FREDERICK COUNTY PLANNING COMMISSION

TITLE: Linganore Town Center PUD

FILE NUMBER: S-829, AP 17198, APFO 17199, FRO 14681, SWM 14679

REQUEST: **Combined Preliminary/Site Development Plan Approval**

Graphic #1: Linganore Town Center Site Aerial

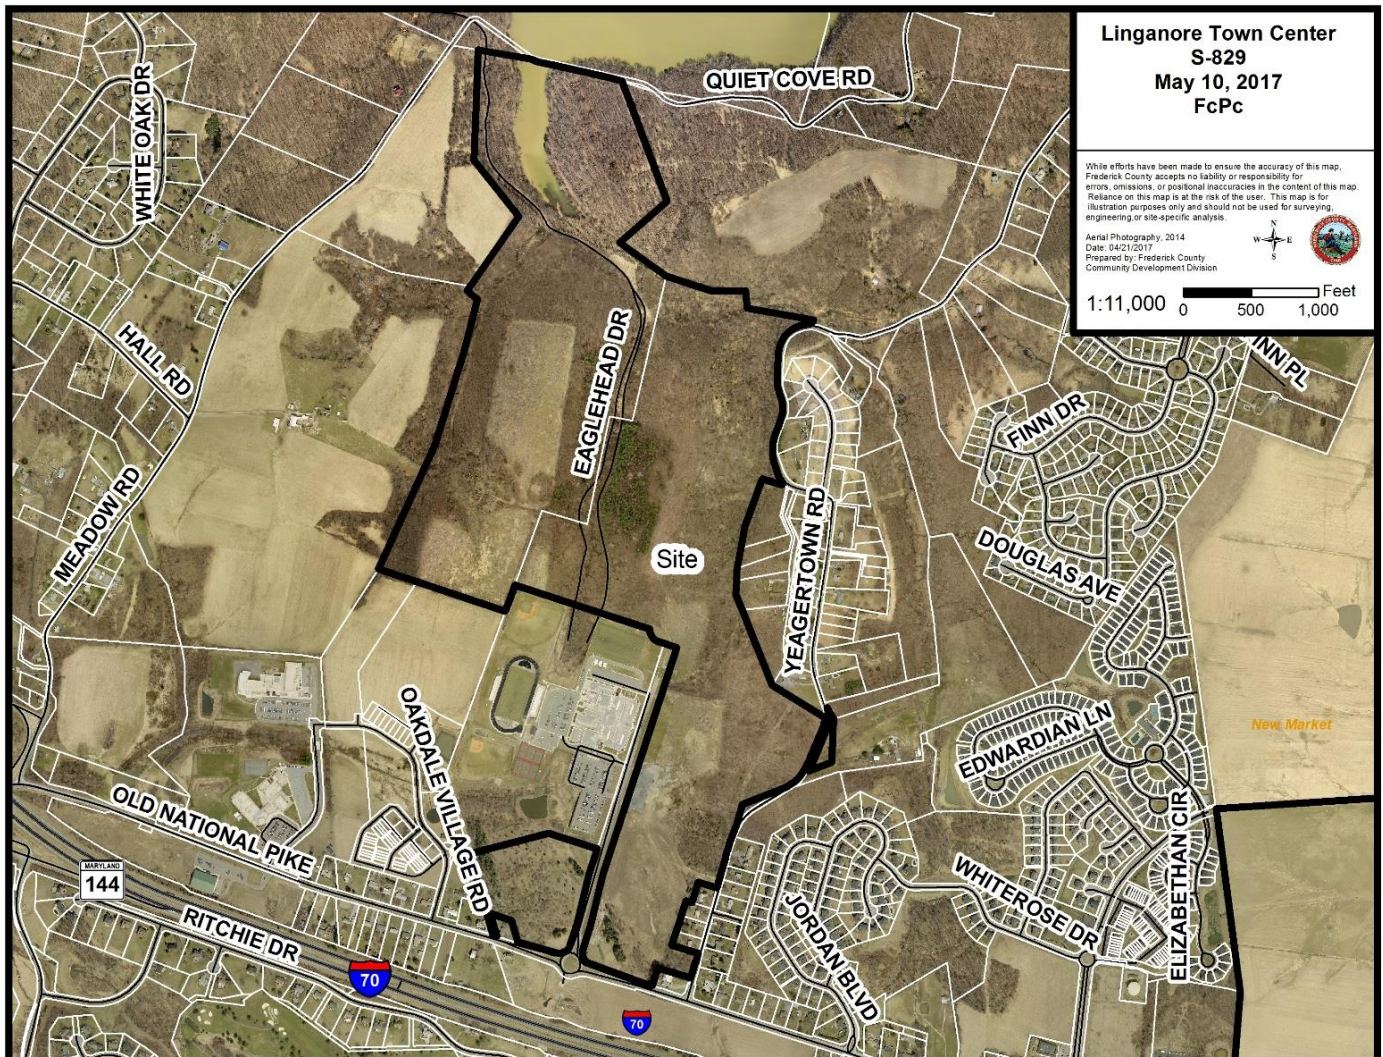
The northern portion of the site contains a second order tributary of Lake Linganore. There are three fingers of NRCS Flooding Soils that run south from this tributary. Two of the fingers are Greenville loam 2 to 5 percent slopes (GvB), with the third as Roche loam 3 to 8 percent slopes (RoB).

The three fingers of flooding soils are located in the lowest areas of the site. This creates two principal areas of developable land which comprises slight to moderate slopes, with some areas of steep slopes in excess of 25%. The two areas of developable land have a topographic elevation range of 430 feet at the far eastern side, to 520 feet as the land continues west, with the former Eaglehead Drive at 400 feet elevation. The topography of the second developable area continues to rise out of the former road bed to the west to a elevation height of 500 feet, then back down to 380 at the western property boundary.
